# OMNIPOL PRAHA ČESKOSLOVENSKO

MANDATORY BULLETIN No. L 13/052

Effectivity: Stabilizer end ribs of the L 13 Blanik sailplanes.

Reason: Eight L 13 Blanik sailplanes operated in the USA were reported have cracks in the radii of stabilizer end ribs

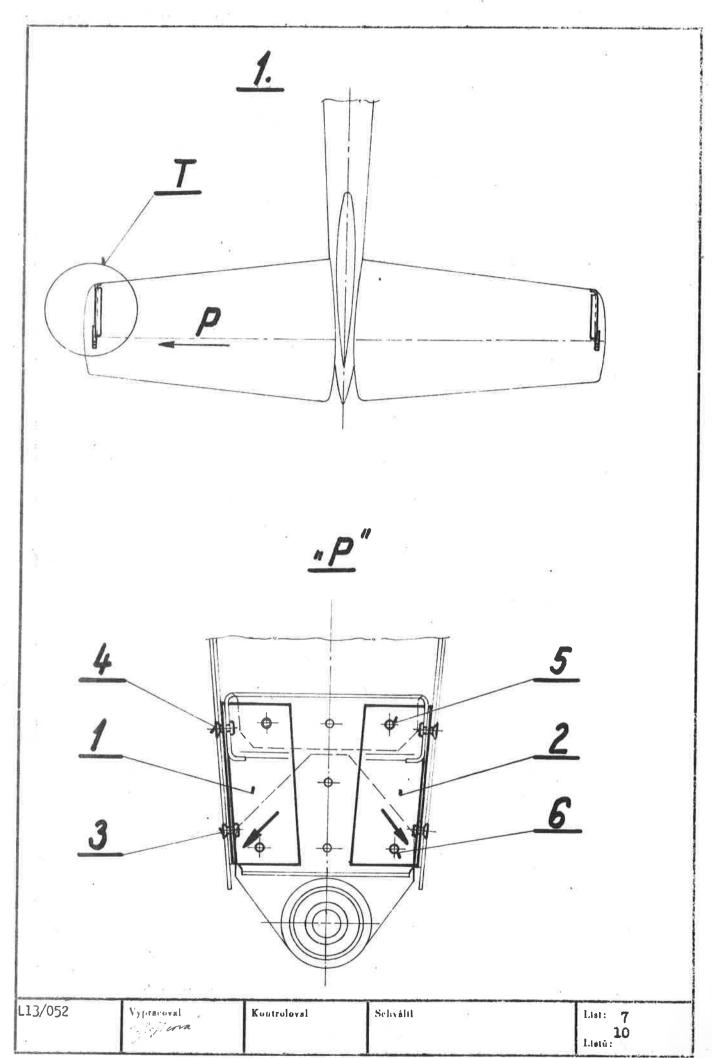
- 2) Carefully drill off original rivets pos. 3 and 5 using a 2.5 mm dia. drill and rivets pos. 4 and 6 using a 3 mm dia.drill. See Fig. 1, view "P".
- 3) Orill holes at the ends of cracks using a 2 mm dia.drill and clean off the holes carefully.

- 4) Locate angle pieces pos. 1 and 2 on the rib see Fig. 1, view "P". Th rough original rivet holes mark-off and centre-punch holes on angle pieces. Orill holes dia 3.1 mm for rivets pos. 4,5 and 6. Holes for rivets pos. 3 to be drilled using a 2.7 mm dia drill and dimpled. Redrill holes for rivets pos. 5 in the spar boom to the diameter of 3.1 mm.

- 5) Deburr carefully drilled hols in the angle pieces and the stabilizer.
- 6) Locate angle pieces in correct position and rivet on.

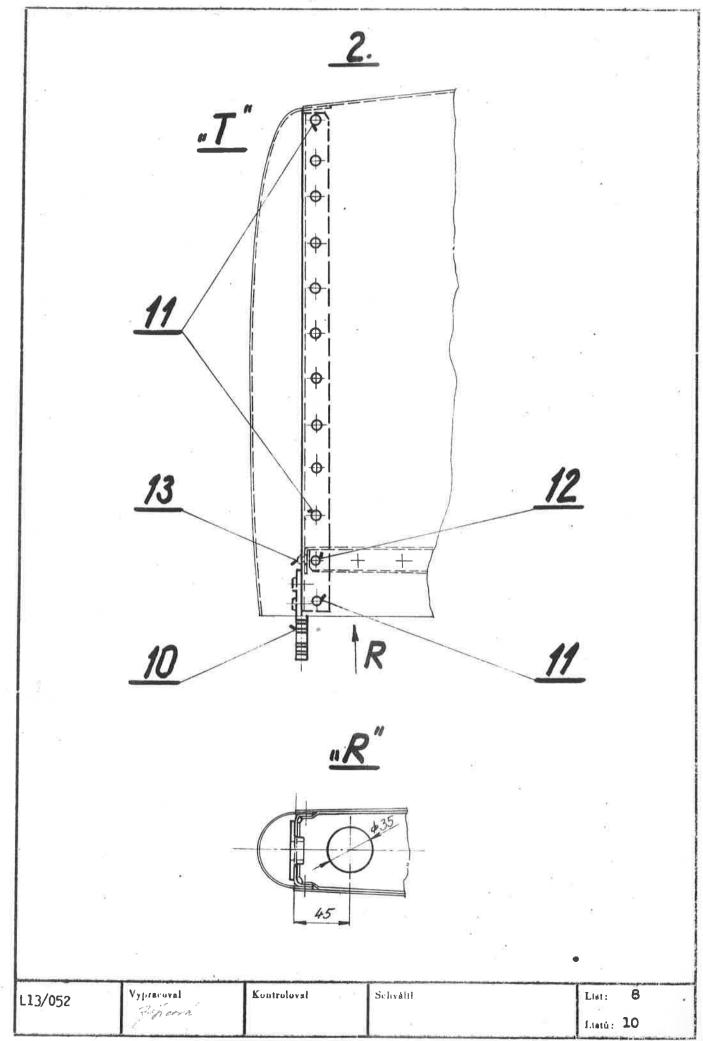
- 1) For elevator removal refer to para. A, items 1 and 2, and to para. B, items 1.
- 2) Mark off distance between inner and outer hinge attachments on the stabilizer.
- 3) Carefully drill off original rivets pos. 11 using a 2.6 mm dia. drill and rivets . pos. 12 using a 3 mm dia. drill. See Fig. 2, view "T" (from Fig. 1).
- 4) Remove tip piece.
- 5) Drill off three rivets pos. 13 fastening end rib to the spar using a 2.6 mm dia. drill. Remove end rib.
- 6) Make a 35 mm dia. hole in the spar and deburr carefully. See Fig. 2, view "R".
- 7) Install new end rib pos. 10 in the stabilizer. Through original rivet holes in the spar mark-off and centre-punch holes for rivets pos. 13 on end rib.

Orill holes using a 2.7 mm dia. drill. Fasten end rib to the spar using e.g. two bolts.

M2. Reinstall tip piece and check the distance between hinge attachments (as marked-off before removing the original and rib). Through original rivet holes drill 2.7 mm dia. holes for rivets pos. 12 in the end rib. It is necessary to keep the distance of 7 mm minimum, between rivet holes and the edge of rib flange.
- 8) Remove end rib and dimple holes for countersunk rivets pos. 11 and 12.
- 9) Reinstall end rib and fasten in with three agrafes at least.
- 10) Rivet end rib on the spar using three rivets pos. 13.
- 11) Remove agrafes, reinstall tip piece and fasten it with several agrafes again.
- 12) Fasten tip piece using successively rivets pos. 11 and 12.
- 13) Refer to para. 8, items 7 and 8 for installation of elevator and of elevator trim tab controls.

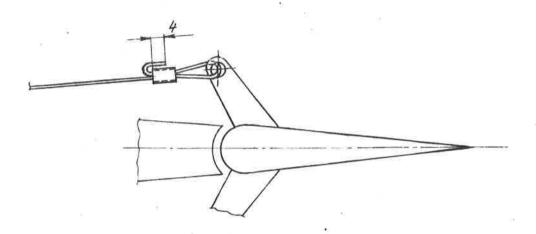
- Stretch strings (cables) by hand by pulling on their ends and fix them to the levers on trim tabs.
  - Typical connection of strings is shown on Fig. 3, connection of cables on Fig. 4.
- Tie the ends of cable with locking wire and solder.
- Adjust trim tab deflections to  $12^{\circ} + 1^{\circ}$  up and  $35^{\circ} + 1^{\circ}$  down by means of turn-buckles between frames No. 14 and 15.
- Stretch the whole control cable system, if necessary, by means of turnbuckles at trim tab rear lever in the cockpit.
- Reinstall upholstered side section.
